The East Pyes Solar Farm – Registration of Interest

We are writing to you to register to have our say in the examination of the NSIP proposal 'The East Pye Solar Farm'.

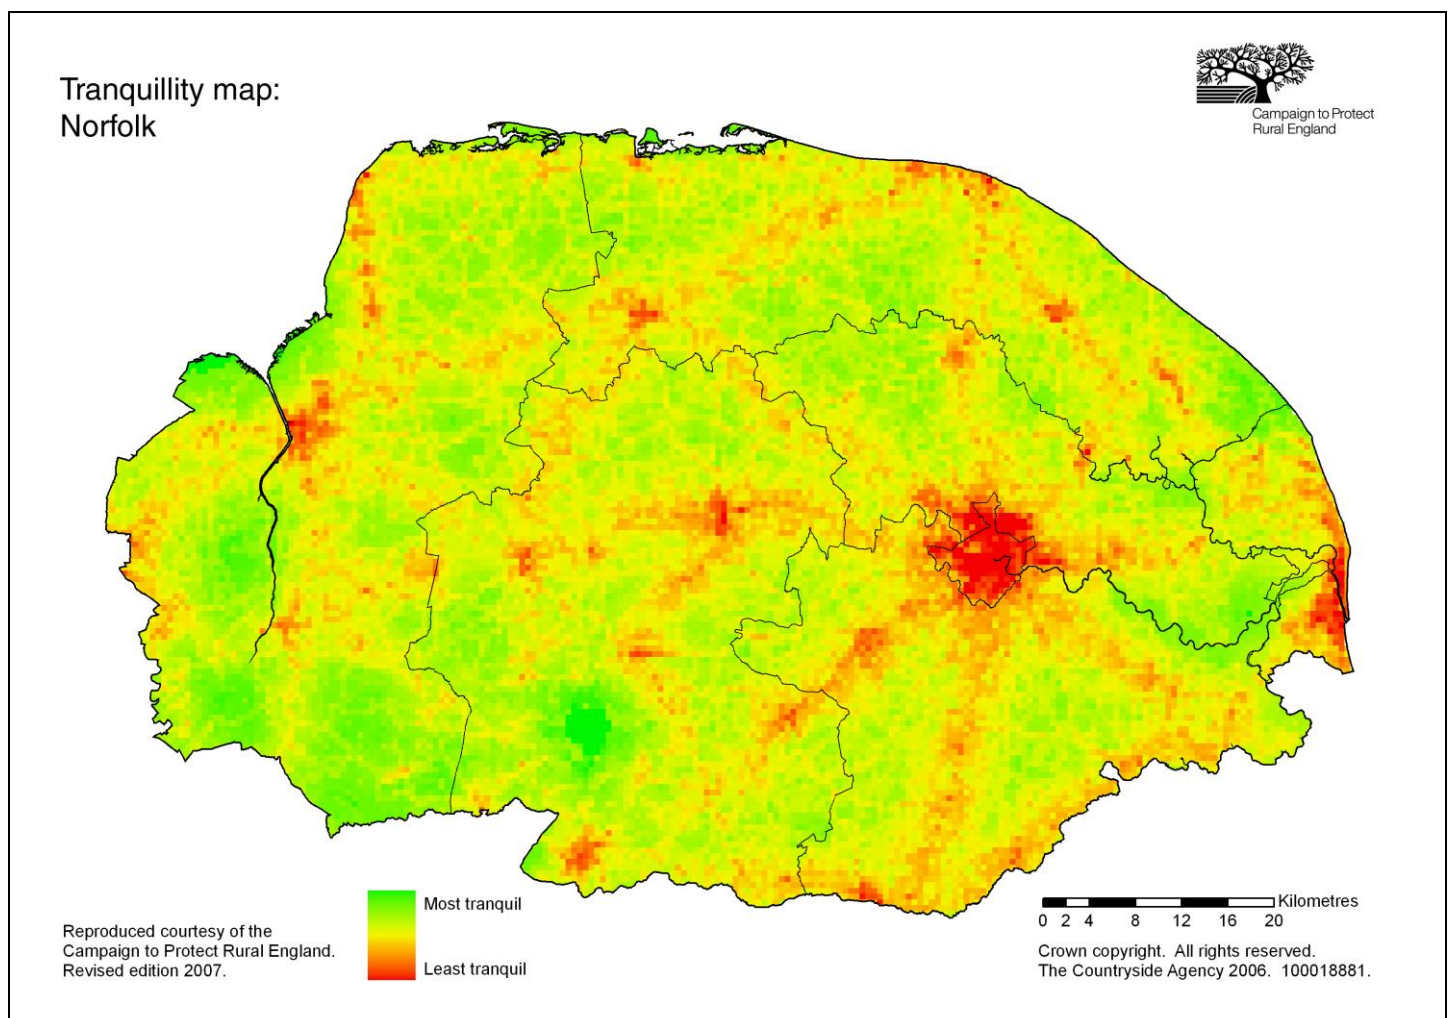
The proposed scale and extent of the solar array will create a significant alteration to the open rural character, especially from nearby public rights of way and minor roads. The large-scale installation of 4.5m solar panels across thousands of acres introduces an extensive, visually intrusive feature. The uniform, reflective nature of PV panels is incongruous with the more organic patterns of field and hedgerow found here. The reflective surfaces and the sheer extent of the development would contrast with the traditional farmland. This could significantly alter the sense of openness and rural tranquillity valued in the countryside.
